Stop the Blocks Community Action Group Community Feedback Report
On Initial Redevelopment Proposals Kennington Stage/Former Woodlands Nursing Home Site-Dugard Way, Kennington, London

September 2021

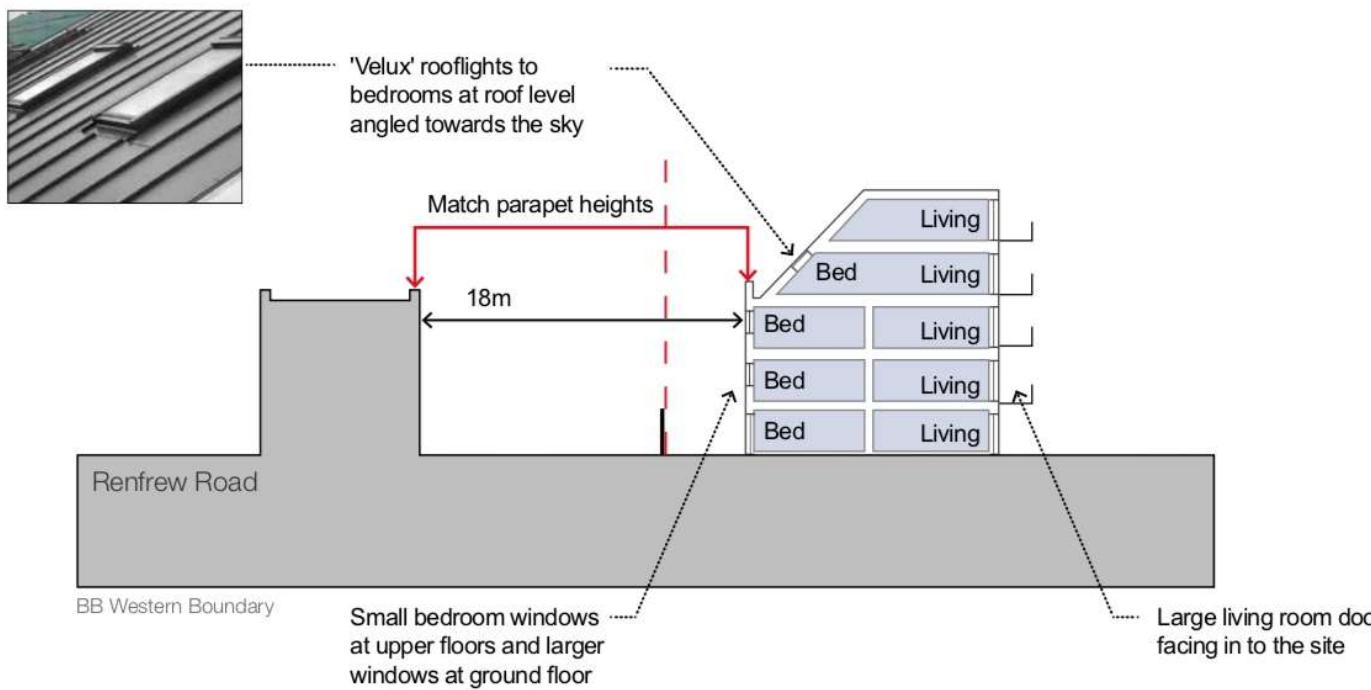
- The removal of balconies and living rooms (which were originally facing the rear gardens on RR) represents a tokenistic change in comparison to the refused scheme, moreover compromised by the increased bulk and closer proximity of the new scheme to the site boundary. Firstly, the Inspector's Report para 69 on pg 14/15, states that it "would be *visually intrusive in the outlook from those dwellings and gardens*" referring to properties on RR, Castlebrook Close and Brook Drive. Secondly, in his conclusions on the issue of amenities of residents of neighbouring properties para 70 to 72, he noted that "The proposed development would have a significant and unacceptable effect on the amenities of residents of dwellings around the site", and the adverse effect on the houses on RR would be "*severe*". This is much worse with this proposed new scheme which is predominantly 4-5 storeys and closer to the RR boundary than the rejected Appeal scheme.

- GF rear extensions where most people's living rooms are have not been considered. The Inspector commented that many people's living rooms were effectively at rear GF along RR boundary. This is where we would consider the 18M should reasonably be measured from, which would give 21M from the main first and second floor RR rear facades to the face of any proposed perimeter block.

- Unlike the previously rejected scheme, the affordable rented and intermediate provision can be spread from D, E and F, into blocks C and B easily. There is no reason why the affordable housing content has to be concentrated along the RR boundary. Unlike the previous scheme, the latest new proposed arrangement allows for it to be distributed around *all* of the perimeter blocks. This would allow the height, scale and massing of blocks along RR

boundary to be reduced down/ pushed back, without reducing the number of affordable units provided by the new proposed scheme.
